# UNITED STATES PATENT AND TRADEMARK OFFICE

APPLICATION NO.	FILING DATE	FIRST NAMED INVENTOR	ATTORNEY DOCKET NO.	CONFIRMATION NO.
10/797,149	03/11/2004	Takashi Ohama	118736	4313
<div>25944      7590      08/21/2007</div> <div>OLIFF &amp; BERRIDGE, PLC</div> <div>P.O. BOX 19928</div> <div>ALEXANDRIA, VA 22320</div>				
			EXAMINER	
			MCCULLOUGH, MICHAEL C	
			ART UNIT	PAPER NUMBER
			3653	
			MAIL DATE	DELIVERY MODE
			08/21/2007	PAPER

## Office Action Summary

### DETAILED ACTION

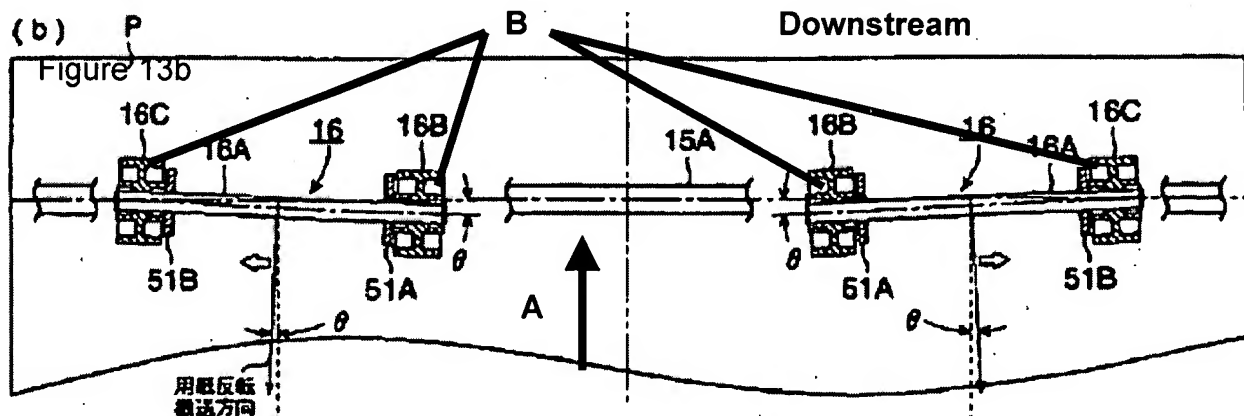
5. Claims 11, 12, 15, 18, and 19 are rejected under 35 U.S.C. 102(b) as being anticipated by Kawano et al. (JP 2000-318904). Kawano et al. discloses a downstream sheet conveying mechanism comprising a first drive shaft (15) perpendicular to a feed direction (see Figure 13b arrow A, below) with four drive rollers (15A-C), a second drive shaft (16) with four segments (see Figure 13b elements B, below) and each segment inclined at an angle of 1-3° (see Page 6 paragraph 0075), and a centermost end of the second drive shaft segment more downstream (16B) than the ends of the second drive shaft (16C).

FIG. 1

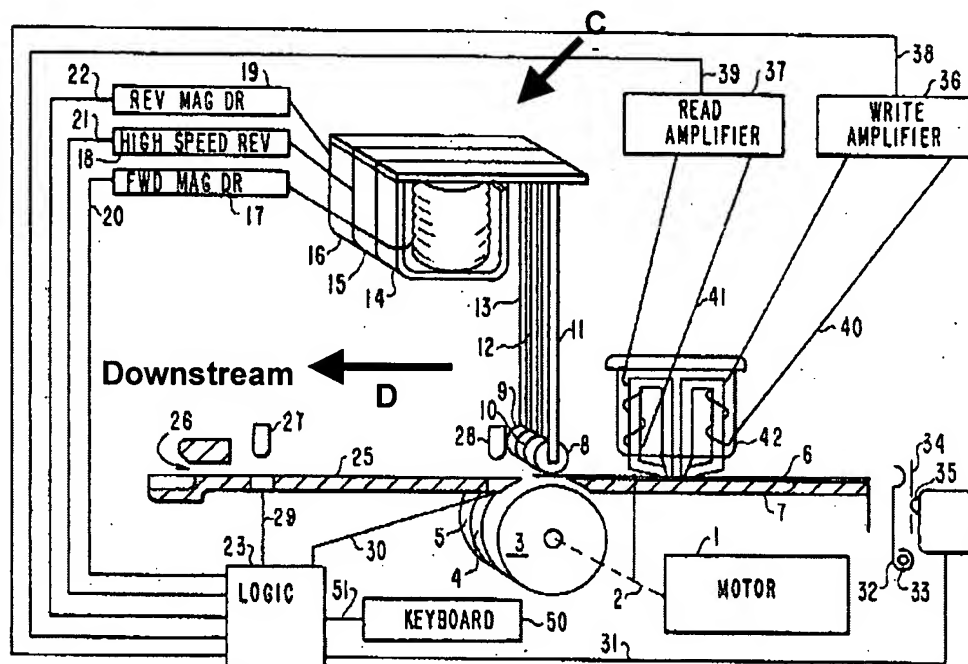
6. Claims 1, 3, 6- 8, and 10 are rejected under 35 U.S.C. 103(a) as being unpatentable over Fowler et al. (US 3,66,262) in view of Sako et al. (US 6,073,927). Fowler et al. discloses a sheet feeder in an image reading apparatus comprising an image reading part (37), a drive roller unit (3, 4, 5) with an axis (2) perpendicular to the sheet feed direction (see Figure 1 arrow D, below) that includes driven rollers and is downstream from the image reading part, a driven roller unit (see Figure 1 element C, below) with the same amount of driven rollers (8, 9, 10) as drive rollers arranged symmetrically with respect to a center line (see Figure 3a line E, below) with axes on a slant (8a and 10a) such that the end portion of each axis far from the center of the width is upstream and the close to the center is downstream, an urging member that urges segments of the driven roller unit independently (see column 3 lines 20-27), and a straight conveying path (7 and 25). Fowler et al. does not disclose the drive roller has a coefficient of friction greater than a coefficient of friction of the driven rollers and a conveying pair upstream from an imaging part and a curved conveying path. However, Sako et al. discloses a similar device that includes the drive roller has a coefficient of friction greater than a coefficient of friction of the driven rollers (see column 6 lines 13-20), a conveying roller pair (22 and 21), and a curved conveying path (23) for the purpose of easily sliding against each other (see column 6 lines 13-20), separating a sheet (see column 4 lines 56-63), and guiding a sheet. It would have been obvious for a person of ordinary skill in the art at the time of the applicant's invention to modify Fowler et al. by utilizing drive rollers with a coefficient of friction greater than a coefficient of friction of driven rollers, a conveying pair, and a curved conveying path as
